WATER PERMIT NO. 7049-3

Application For Permit To Appropriate Water Within The State Of South Dakota

Steve Kane Grant County Pond Repair

**RECOMMENDATION OF CHIEF ENGINEER FOR WATER PERMIT
APPLICATION NO. 7049-3, Steve Kane**

Water Permit Application No. 7049-3

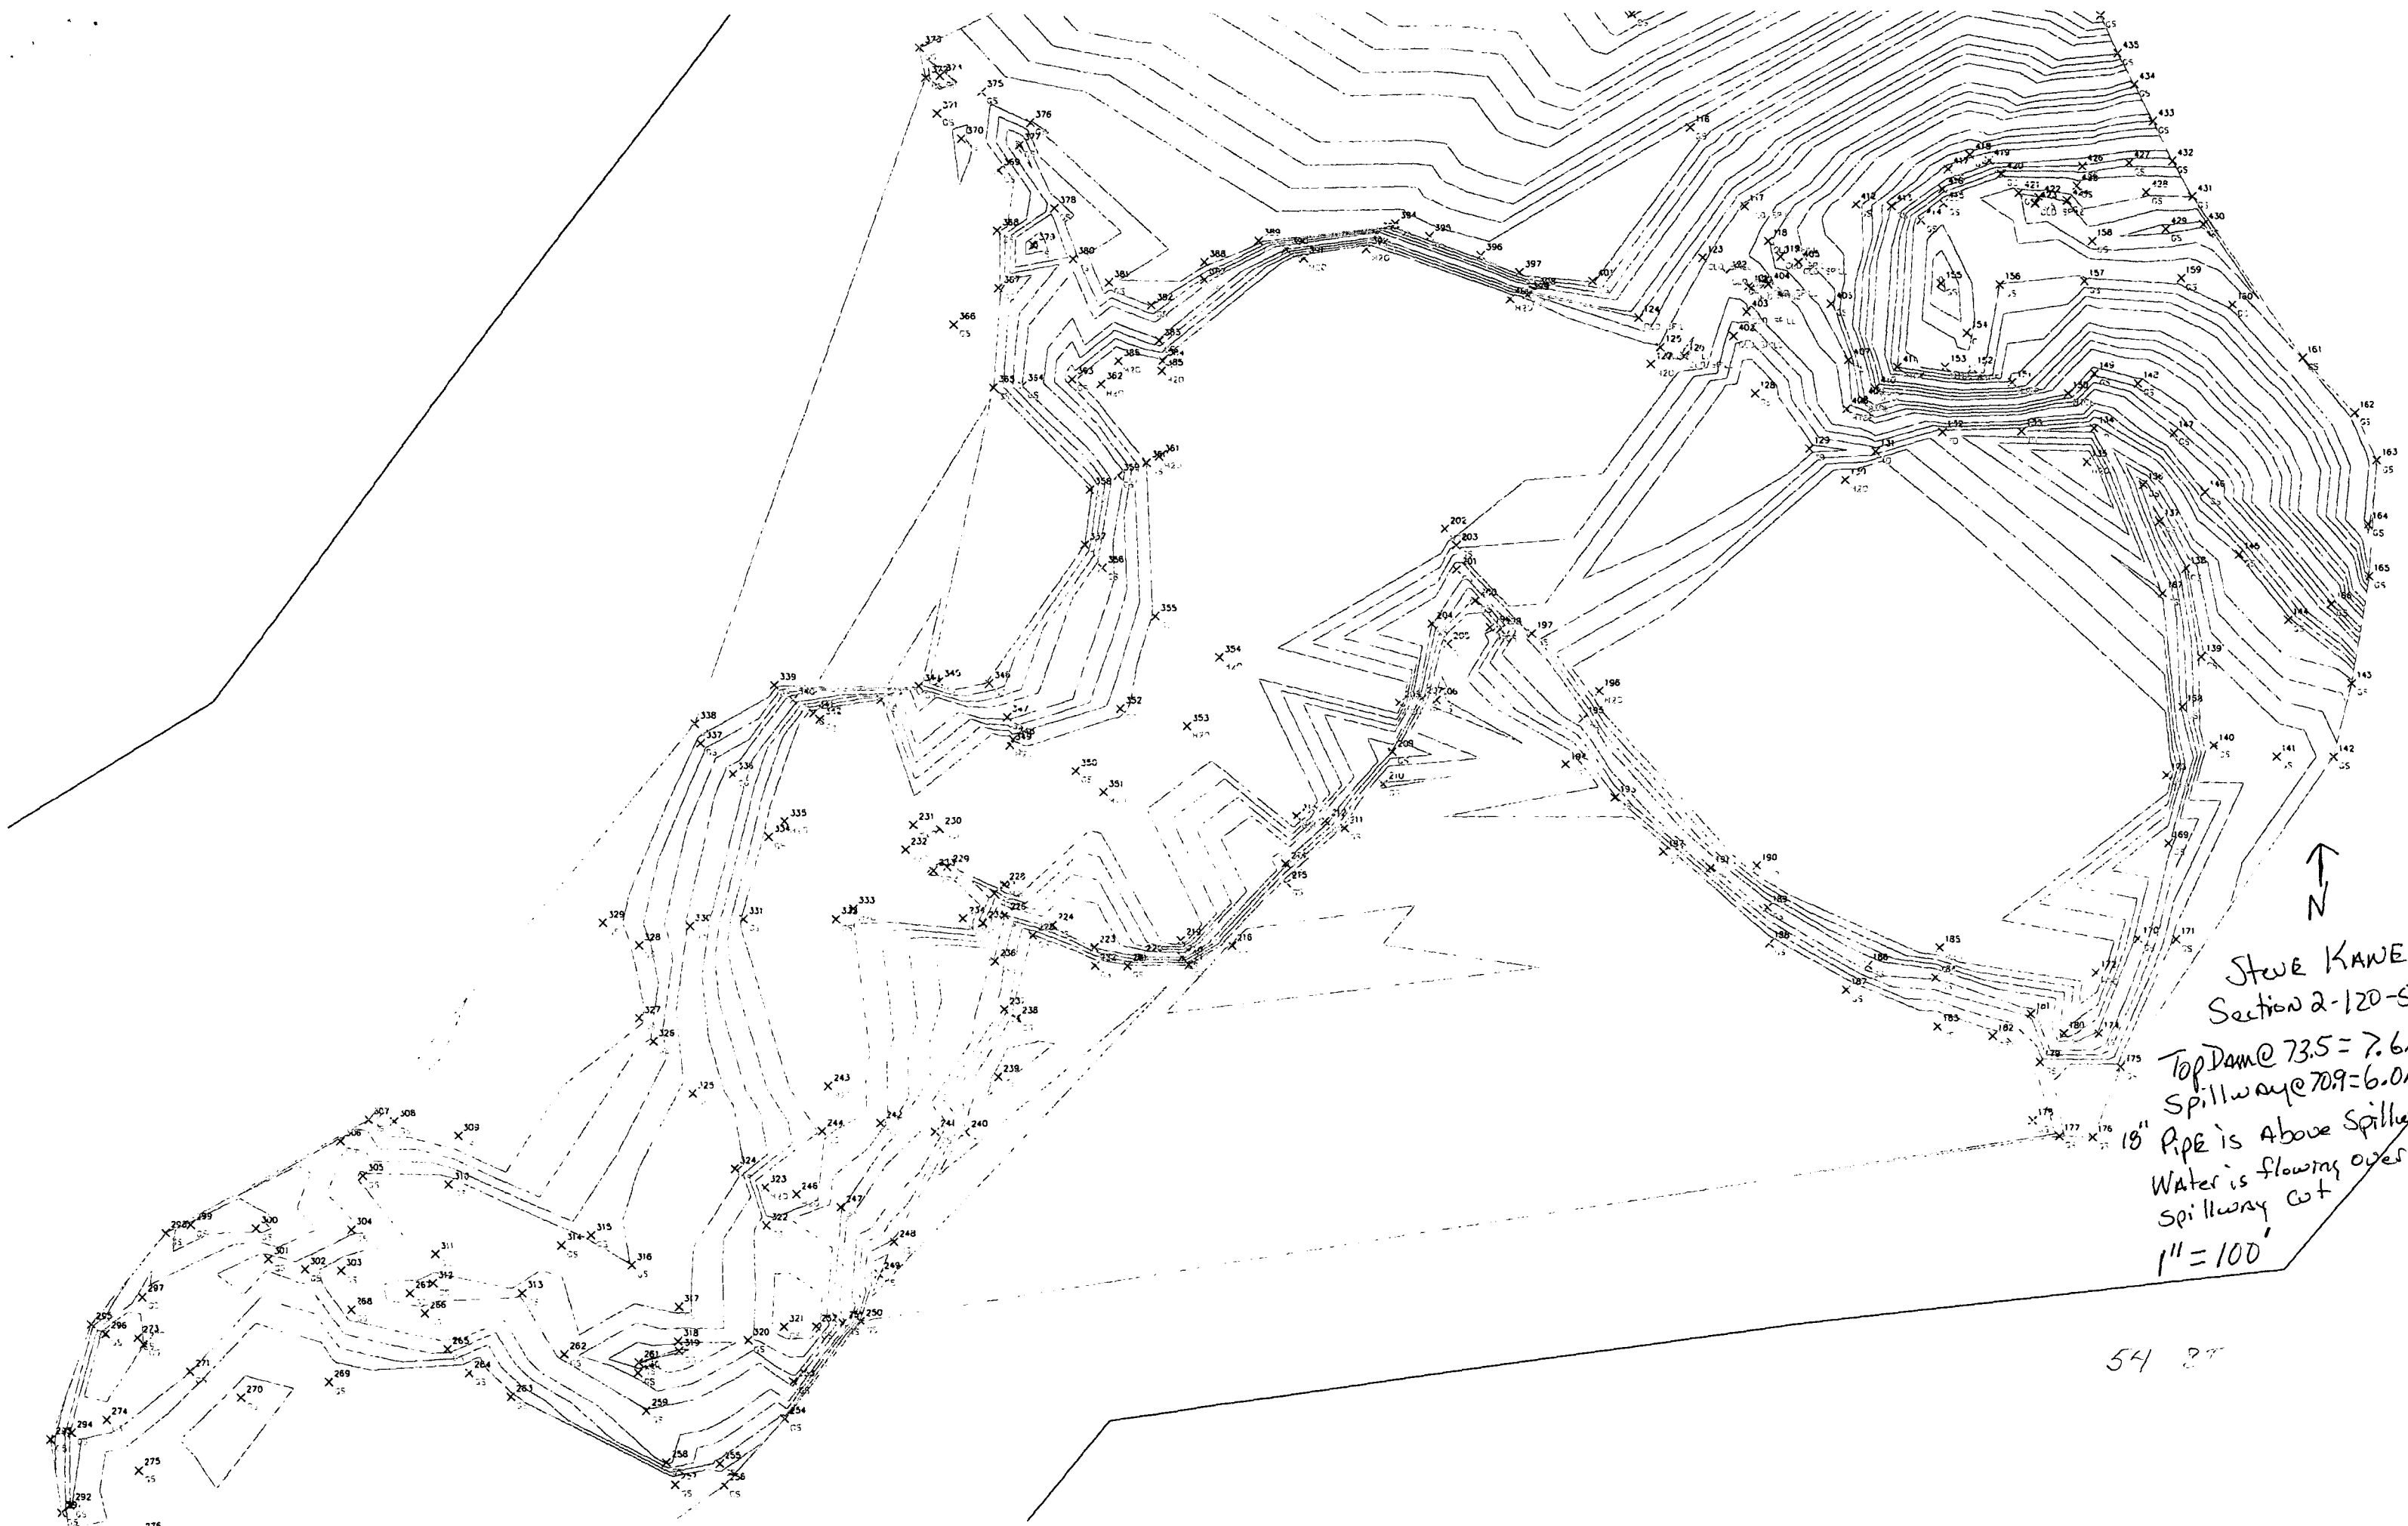
Int. Capacity x Eff Ht. = $51 \times 17 = 867 < 3000$ $\therefore$ 25 yr
Minimum Spillway Design

1. Topo Map - OK
2. Dam Axis Profile - OK
3. Dam Max X-Sec. - OK
4. Area Capacity - OK
5. Outlet Details - OK
6. Spillway Rating - OK
7. Spillway Details - OK
8. Specs. - std NRCS - OK
9. EPP - N/A Cat. 3 - OK
